Solar Farm - 87 Upper Sefton Road, Sefton

RC 235259 Application for Resource Consent

1. Landscape Assessment Peer Review

ECAN Shelterbelt Guide

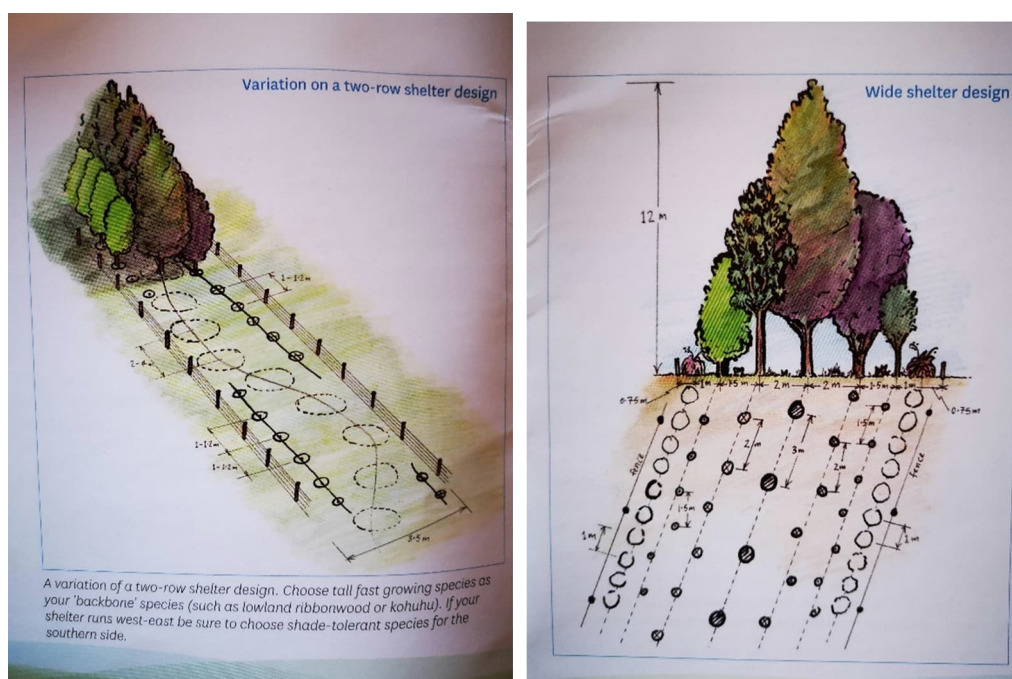
Organic planting patterns helping to break up the visual wall of single species in areas when / if combining with natives (end of ephemeral streams for example). Wider and potentially taller shelterbelts in corners where land is poorly utilised.

Utilising two row where appropriate with mix of exotic and native where practicable

Utilising unused space in corners that are unable to have panels, to mitigate high use road views
